DETROIT EDISON-FERMI 2
 AUTOMATED RECORD MANAGEMENT
 DISTRIBUTION CONTROL LIST
 01/17/90

LCR 89-239-1UFS

PART 1: UFSAR, PLAN, OR PROGRAM REVISION [] NA

LCR 89-225-UFS
 REV 0
 PG. 6 OF 7
 UFSAC FIG. 6-2-20
 (CONT.)

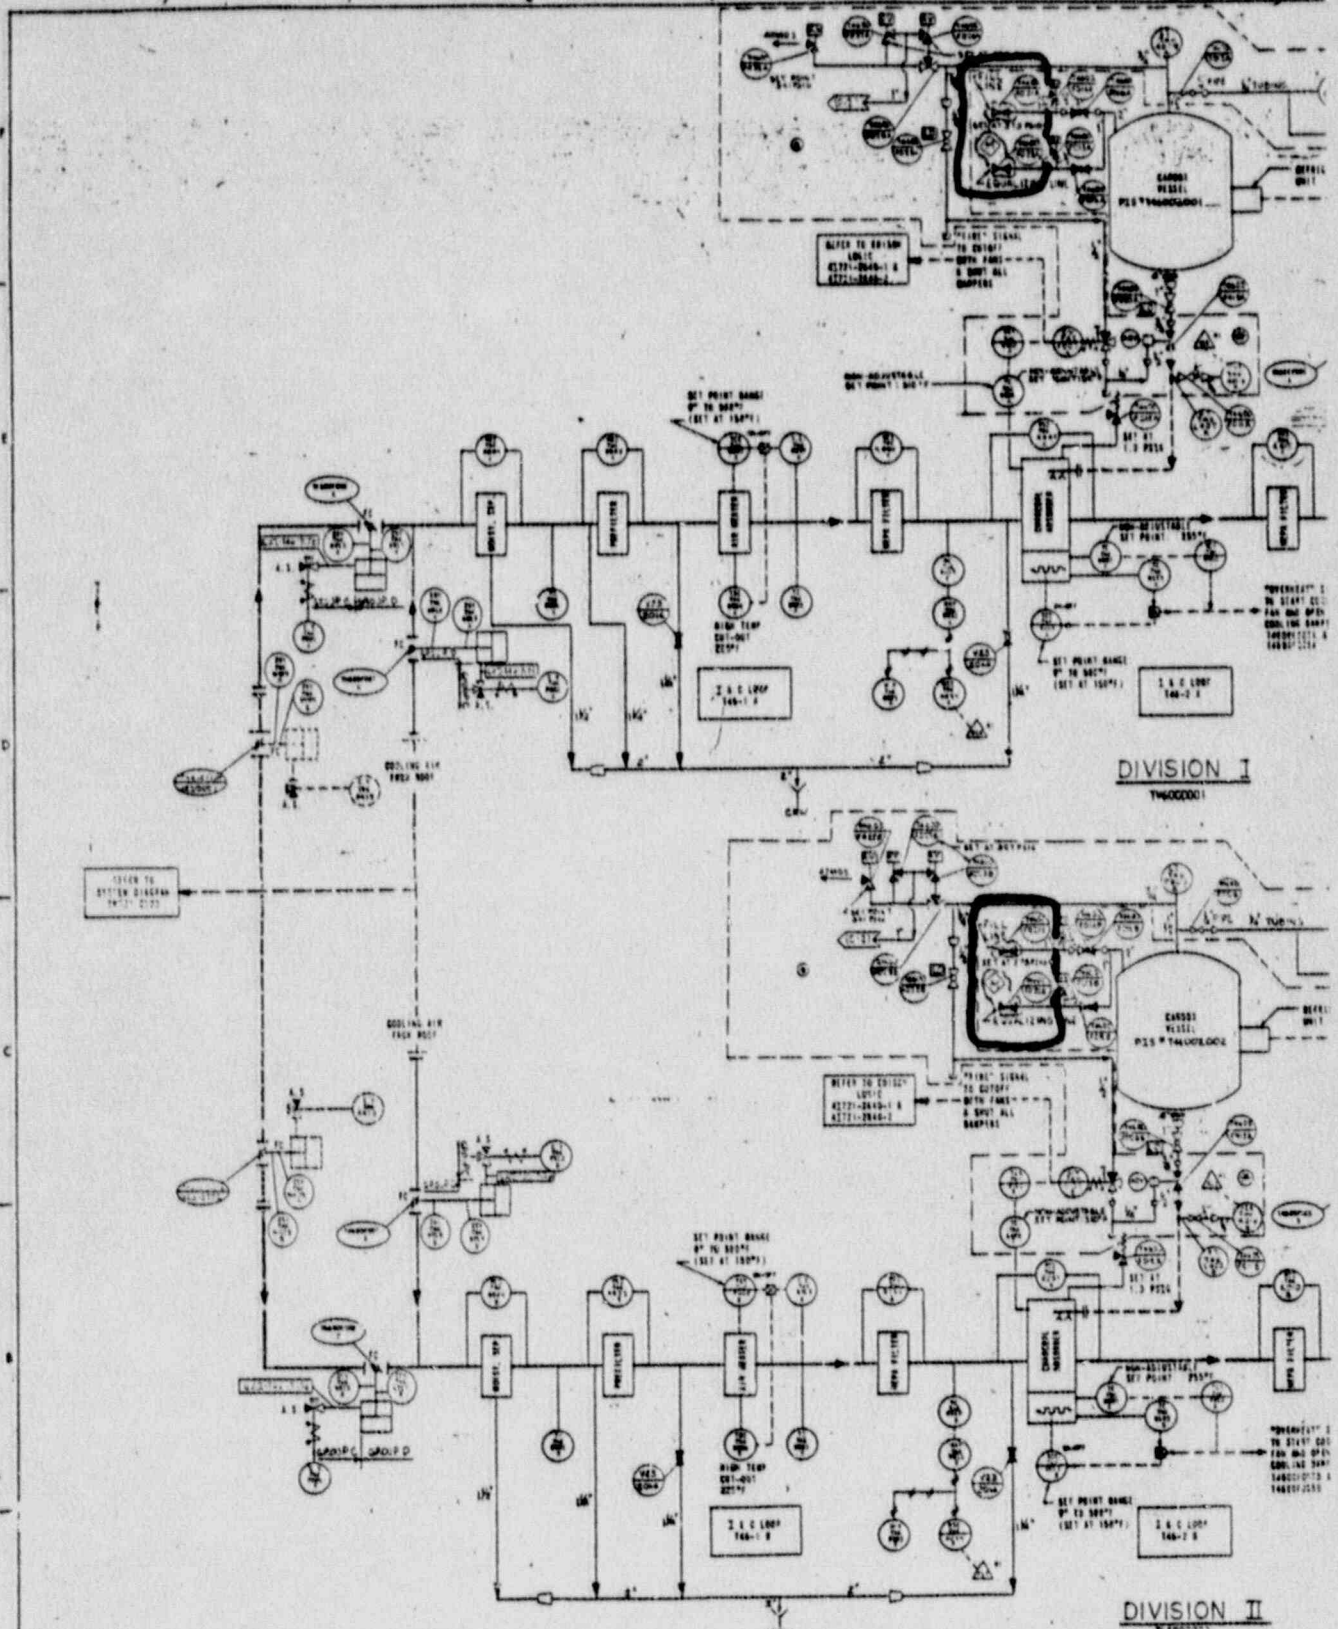
B) Section(s), Table(s), Figure(s), etc. Affected (Attach marked-up pages)
FIGURE 6.2-20

C) Reason for Change TO SHOW VALVES IN THEIR NORMAL OPERATING POSITION.

Section/Page	Change	Basis
UFSAR FIGURE 6.2-20	SHOW VALVES T4600- F021A, F021B, F022A AND F022B IN THE CLOSED POSITION.	IN THE NORMAL PLANT OPERATING CONFIGURATION THESE VALVES ARE CLOSED. THE VALVES ARE OUTBOARD ISO- LATION VALVES ON THE FILL AND EQUAL- IZING LINES FOR CARDOX VESSELS T46002001 & T4600- 2002 AND ARE OPENED ONLY DURING CARDOX VESSEL FILLING OPERATIONS. SHOWING THESE VALVES AS CLOSED WILL NOT AFFECT THE OPERATION OR PERFORMANCE OF THE FIRE SUPPRESSION OR STANDBY (CONT'D, PG. 9)

UFSAR Figure 7.5-1
Sheet 1

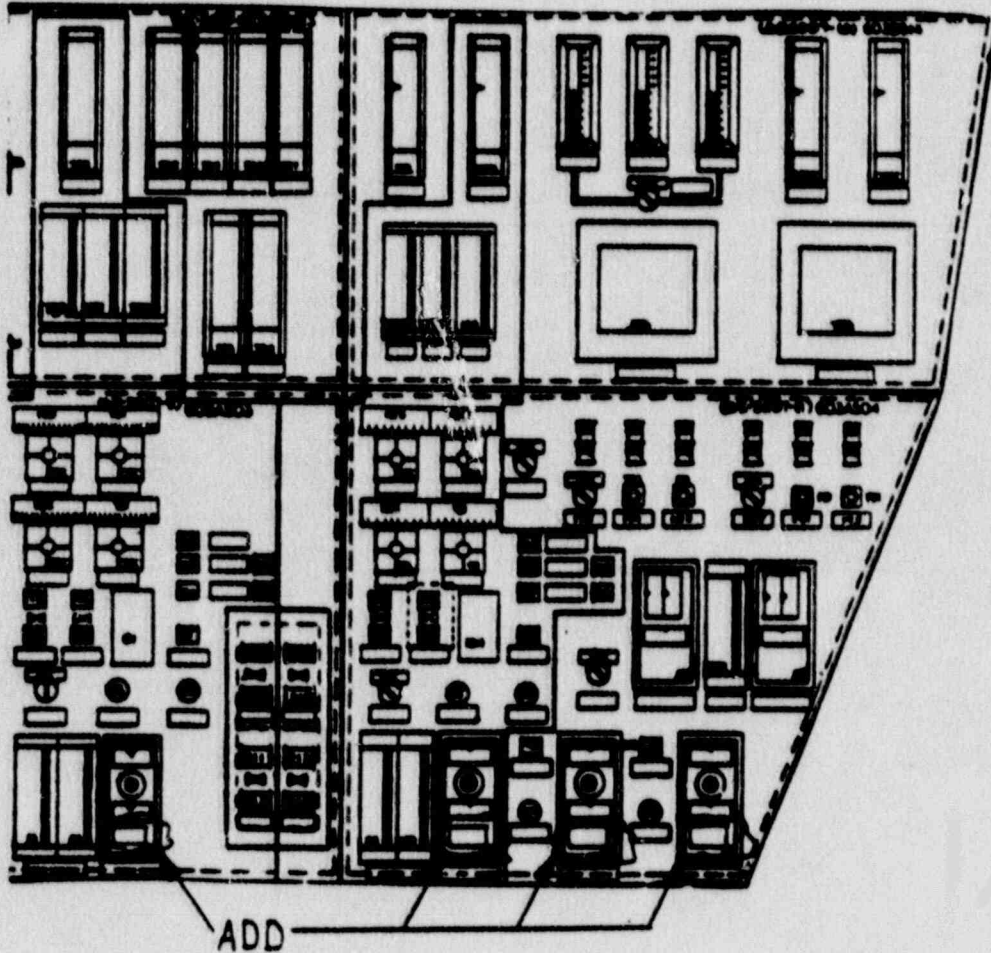
Figure 7.5-1 Sheets 1 and 3. 61321-2007-1 61321-2007-2

C) Reason for Change Feedwater and Recirc system label changes on Panel H11-P603

FIGURE 7.5-10
 MAXIMUM TIME AVAILABLE FOR OPERATOR ACTION

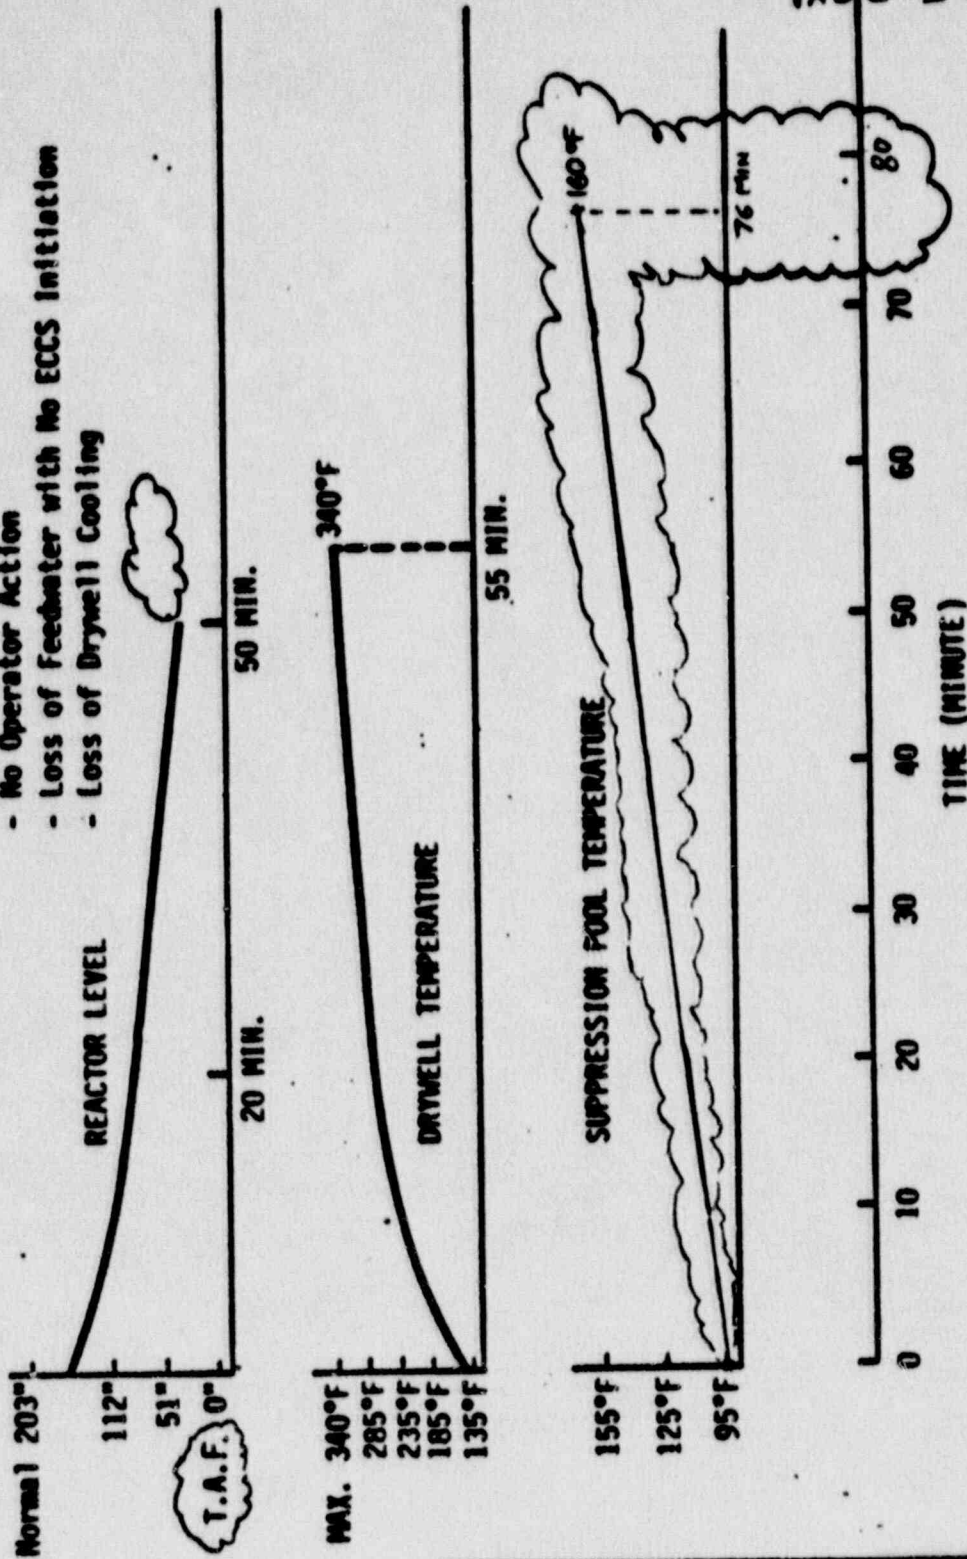
- A) Document UFSAR FIGURE 7.5-10 CONTROLLED
- B) Section(s), Table(s), Figure(s), etc. Affected (Attach marked-up pages)
UFSAR FIGURE 7.5-10
- C) Reason for Change THE REVISIONS OF NF-89-0269 REVISE THE TRAVEL TIME CURVE TO MATCH INPUT FROM THE RE. LEVEL CURVE USING THE RETAIN EXISTING CURVE.

Section/Page	Change	Basis
UFSAR FIGURE 7.5-10	REVISE SUPPRESSION POOL TEMPERATURE CURVE TO SHOW TEMP AT 160°F AT 76 MINUTES RATHER THAN THE PREVIOUS 200 MIN.	THERE IS NO DECREASE TO THE FIRE PROTECTION PROGRAM AS THE DEDICATED SHUTDOWN PROCEDURES DESCRIBED IN UFSAR 7.5.2.5.4 REQUIRES 60 MINUTES TO COMPLETE. THE 60 MIN IS LESS THAN THE 76 MINUTES PREDICTED IN THE ORIGINAL AND REVISED CURVE. SINCE TORUS COOLING IS STILL ESTABLISHED AS DESCRIBED IN UFSAR 7.5.2.5.4, THE FIRE PROTECTION PROGRAM IS BEING COMPLETED AS DESCRIBED IN FSAR AMEND 60 AND SSER 5.
UFSAR FIGURE 7.5-10	REVISE T.A.E. TO T.R.F., AS IT STANDS FOR TOP OF ACTIVE FUEL	EDITORIAL CHANGE.
